# Service Bulletin

Bulletin No.: 22-NA-089

**Subject:** Intermittent Click Noise at Front of Vehicle, ABS, Traction Control System (TCS)/  
Stabilitrak Lamps May Illuminate Intermittently and/or Deactivate for Ignition Cycle -  
DTC P215B, C0035-C0051 Set

5317528

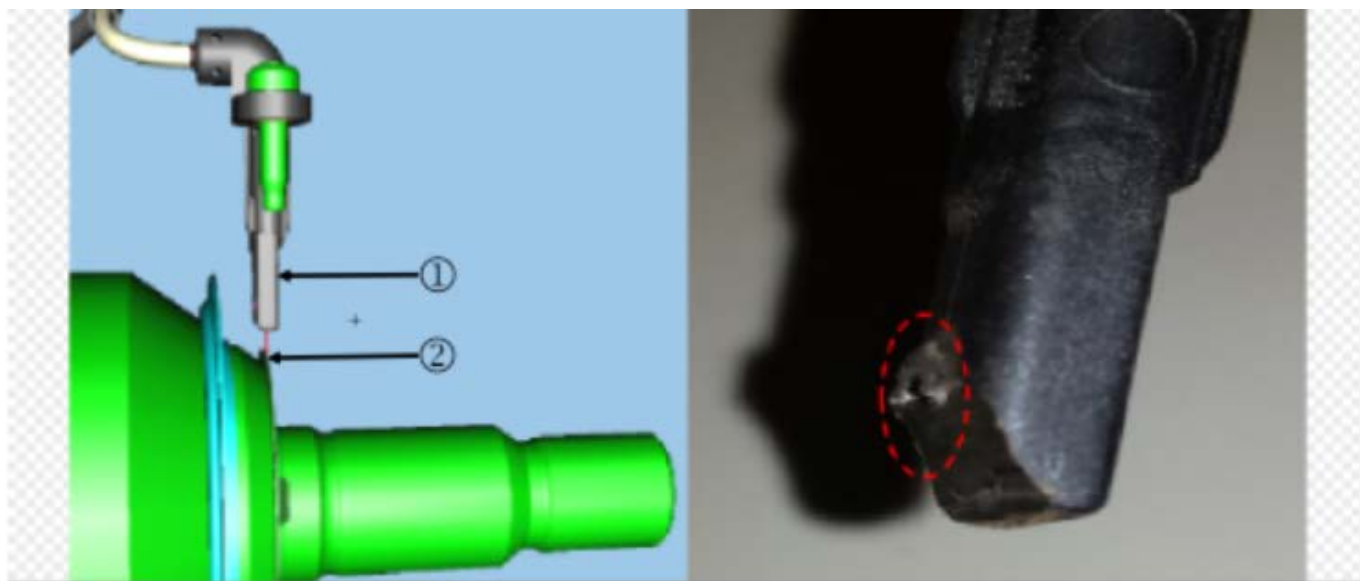
2. Remove the anti-click washer (1) from the outboard joint of the half shaft (2) and discard. Then replace the anti-click washer with new part number shown below.
3. If affected, repeat steps #1 and #2 on the opposite side.

5317529

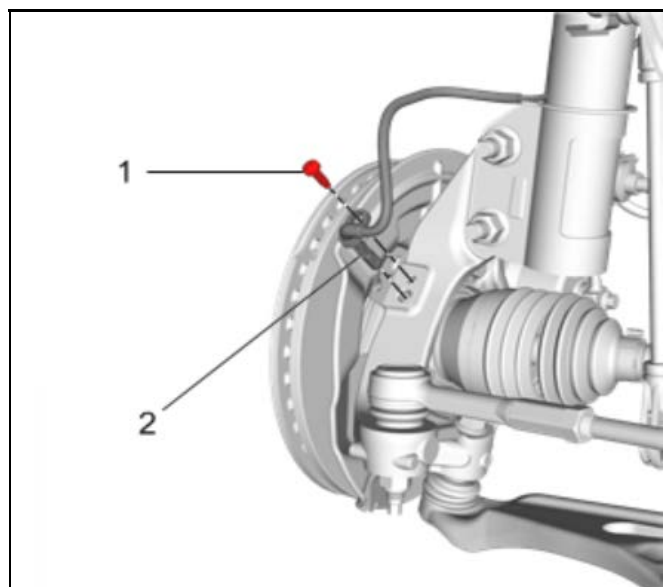
Note: The example above depicts the wheel speed sensor (WSS) (1) directly in-line with the anti-click washer (2) on the outboard joint of the half shaft.

4. Inspect the WSS on either/both affected side(s) for possible damage.
  - " If no damage is found, reinstall the lower control to the steering knuckle, and no further repairs are necessary.
  - " If the WSS is found to be damaged (as shown circled in the graphic above), continue ahead to step # 5.
